DEVELOPMENT PERMIT STAFF COMMITTEE MEMBERS

EXECUTIVE SUMMARY

To develop this site with an eleven (11) storey mixed-use building containing Social Service Centre (main - third floor) and Social Housing (fourth - eleventh floor), containing a total of one hundred & five (105) dwelling units, all over one level of underground parking, providing a total of fifteen (15) parking spaces having vehicular access from lane.

THAT the Board APPROVE Development Application No. DP-2020-00721 submitted, the plans and information forming a part thereof, thereby permitting the development of an eleven (11) storey mixed-use building containing Social Service Centre (main - third floor) and Social Housing (fourth– eleventh floor), containing a total of one hundred & five (105) dwelling units, all over one level of underground parking, providing a total of fifteen (15) parking spaces having vehicular access from lane, subject to the following conditions:

Figure 4: Shifting the DEOD's Prescribed Height-Massing Envelope eastward shows that the proposed building's height and massing is more or less within the boundaries of the DEOD envelope.

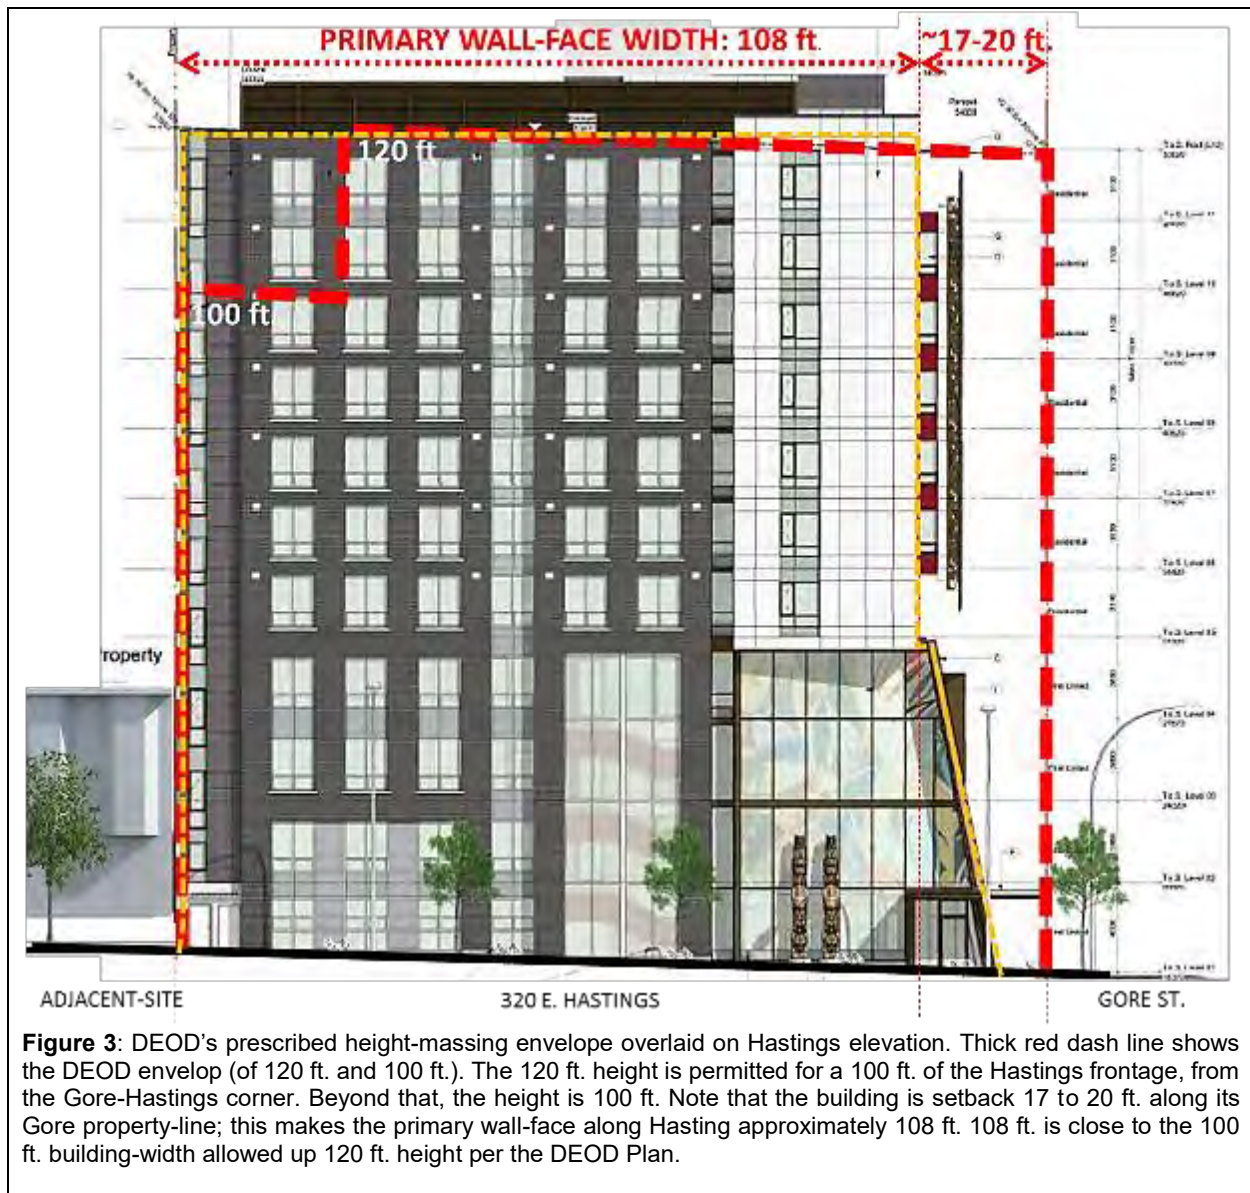
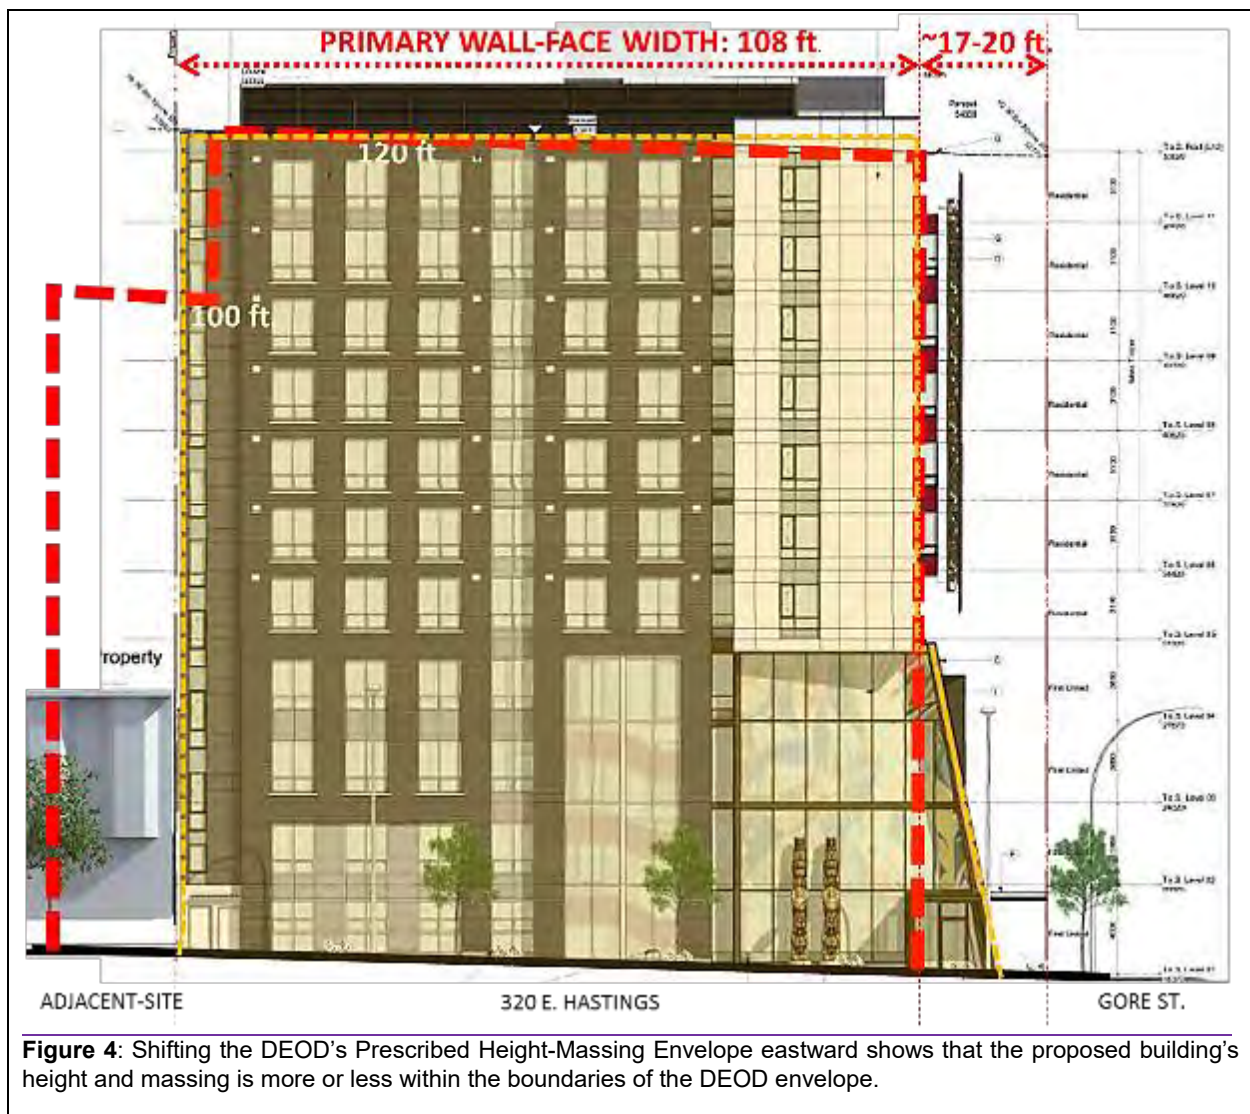
Staff do recognise there are portions of the building above the 120 ft. height, but these overages are mainly of mechanical-electrical spaces, elevator overruns, stair-accesses, guard-rails, urban agriculture plots, and seating-area. These structures do not add to additional enclosed floor-area, and are well setback from the roof-edge so as to not appear highly visible when seen from the ground level.

To aid the delivery of housing to a vulnerable population, relaxations of some aspects of the by-laws and design guidelines should be considered. From this line of thinking, Staff seek the Development Permit Board's relaxation of the height and density by invoking Section 1.3 of the DEOD Plan to allow this building, despite its total site width being 125 ft., to achieve its proposed 125 ft. height and 7.0 FSR. Specifically, Section 1.3 would be invoked to increase the limits in 4.5.3 (density) and 4.6.1 (height) of the DEOD Plan. This relaxation will allow the easternmost 25 ft. of the site to build up to 125 ft.

Figure 5: Plan-view, 3D-view and Section-view showing the lightwell provided along the building's easternmost wall to minimise impacts of access to natural sunlight and air for the neighbouring building.

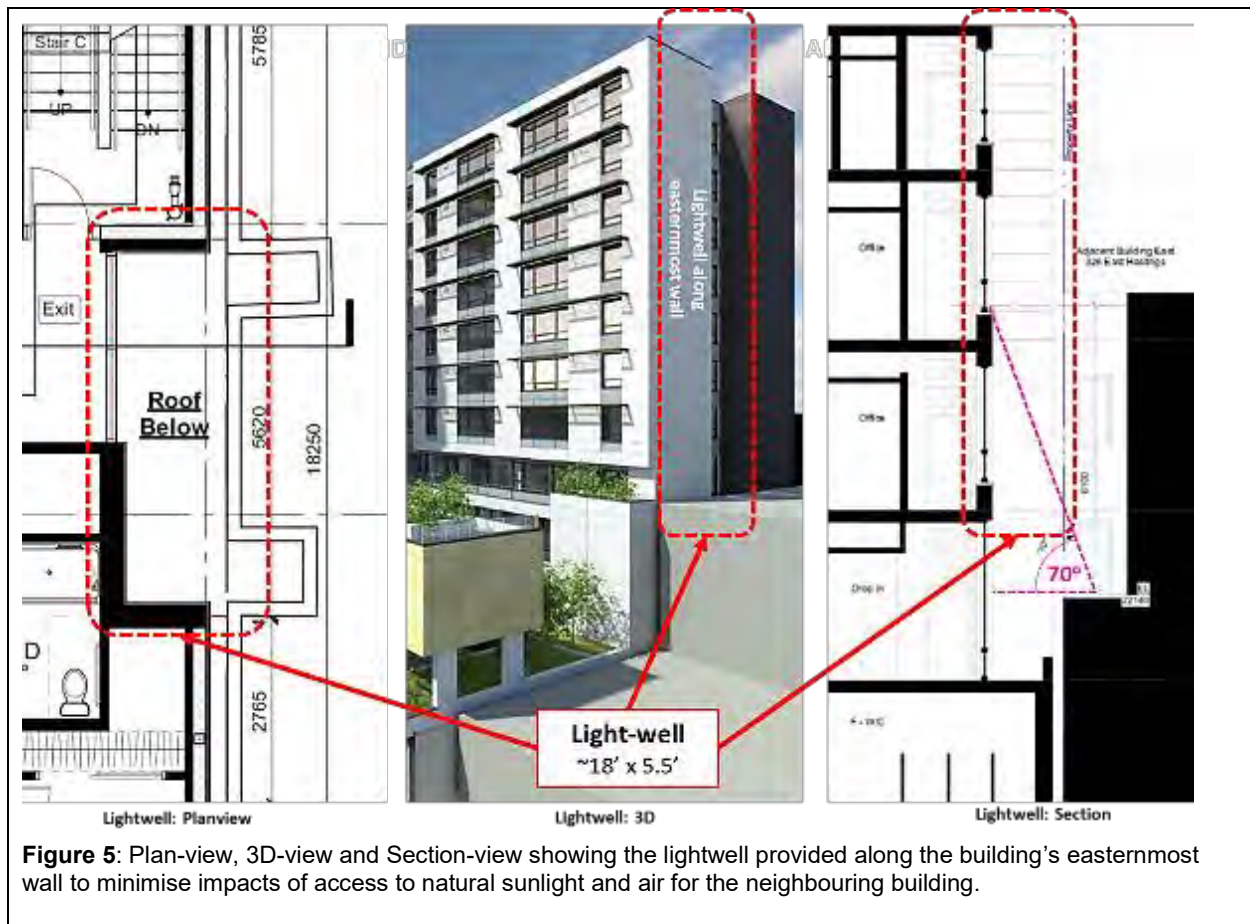
Noting three-storey building to the immediate east has two small lightwells near the shared property-line, the applicant has provided a corresponding lightwell to minimise access to natural light and air for this neighbour. The lightwell is approximately 18 ft. x 5.5 ft. and extends the full height of the building's easternmost wall. (See Figure 4)

- Recommended Condition 1.4 recommends improving privacy, general access to light and air, and safety for residents of the proposed development, as well as for the adjacent neighbours.

- v. use obscured or frosted glass for the lightwell to minimise overlook and direct sightlines into the easterly neighbour's windows; and
 - vi. provide a shadow study (10:00am to 4:00pm on the equinoxes) comparing the shadows of this proposed building versus one that is built to the DEOD's prescribed height-envelope;

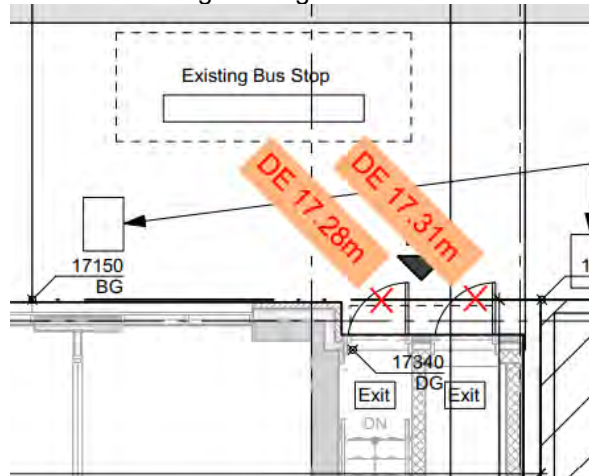
- i. correct BG elevation on the south west corner (BG 16.30m);

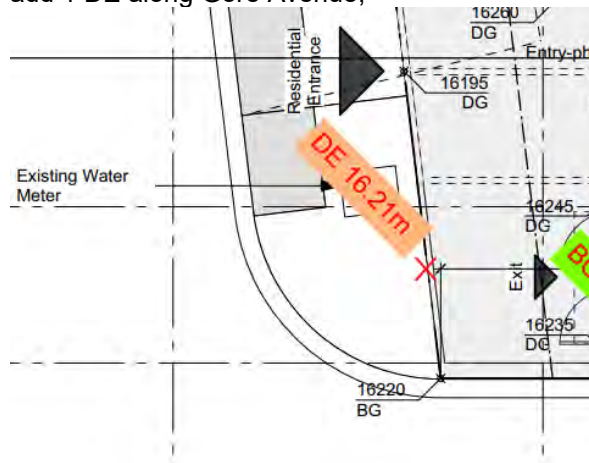
- ii. add 2 DE's along Hastings Street at entrance/exit doors;

- iii. add 1 DE along Gore Avenue;

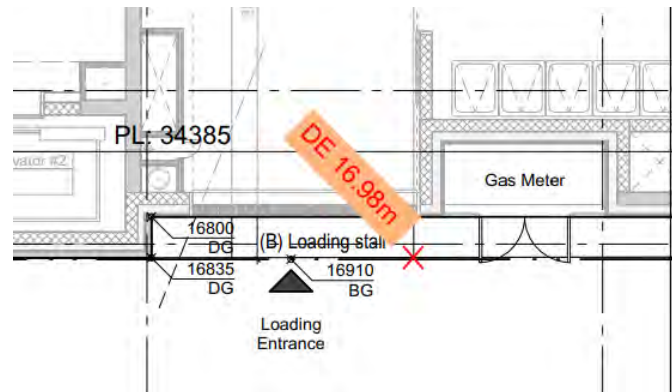
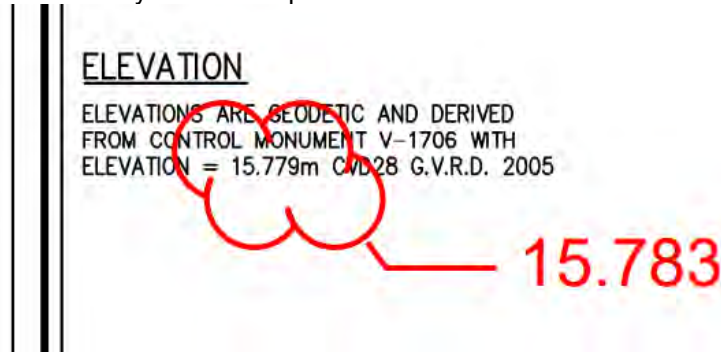
- iv. add 1 DE along the lane; and

- v. V-1706 survey monument posted elevation is 15.783m and not 15.779m.
